DEDHAM-WESTWOOD WATER DISTRICT
BURGESS AVENUE BOOSTER PUMP STATION REPLACEMENT

ADDENDUM NO. 2

To be considered as part of the contract drawings and specifications for the Burgess Avenue Booster Pump Station Replacement project.

Sheet Number:
E300

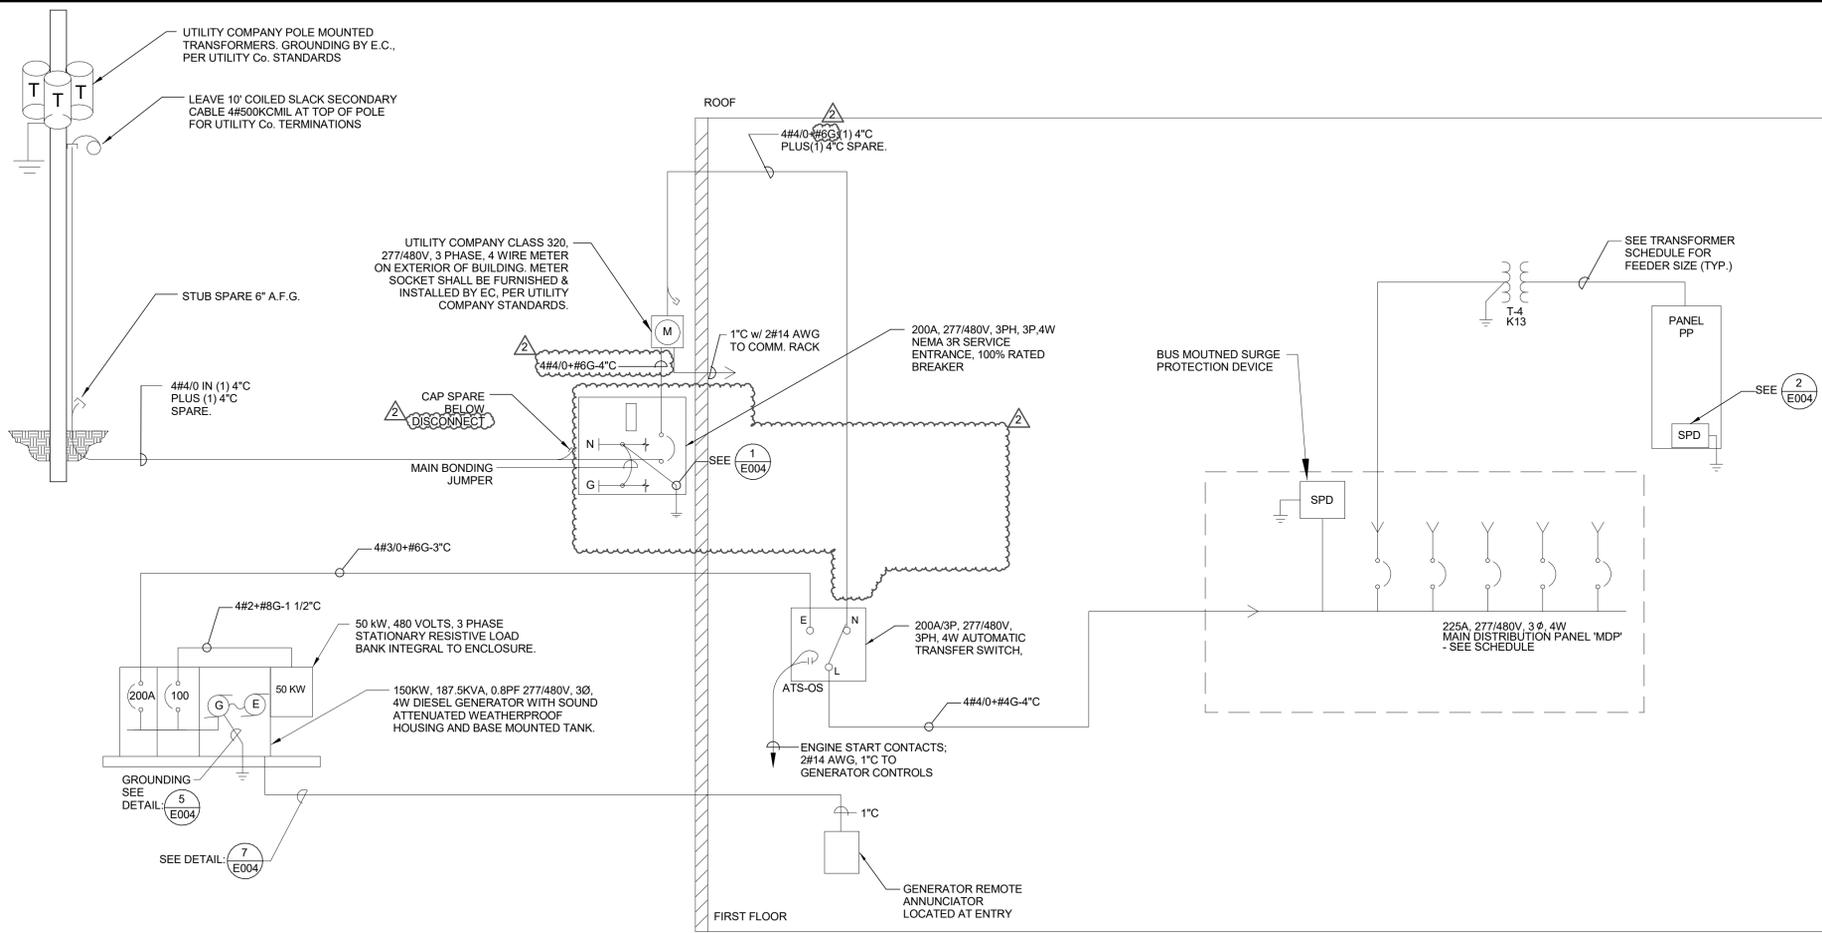
1. **Q:** Drawing E300 utility one line call out to leave 10-foot coiled slack (4) 500kcmil for utility terminations at the top of 4-inch riser conduit and also states that there are four 4/0 conductors in the same 4-inch ductbank back to meter socket. Please advise on the correct wire size that is to be used in Ductbank A-A.
A: Ductbank A-A wire size is 4#4/0 from the top of the pole to the meter.

2. **Q:** E300 shows four (4) water pump drives on the schedule of mechanical equipment. Where are they shown on a one-line, and where are (is) the schematic diagram for these drives so that they can be designed accurately?
A: The pumps are circuited, wire and conduit size, via the "SCHEDULE OF MECHANICAL, PROCESS, & PLUMBING EQUIPMENT" in lieu of being shown on the one-line diagram. A VFD diagram is not provided as the VFDs should be wired per the approved manufacturer's requirements.

3. **Q:** Eversource utility handbook section 705 states that there shall be a cold sequence service disconnect on all ampere 277/480v 3 and 4 wire installations. E300 one line does not show a service disconnect. Please advise.
A: Confirmed, the metering must be cold sequenced, see revised drawings E100 and E300.
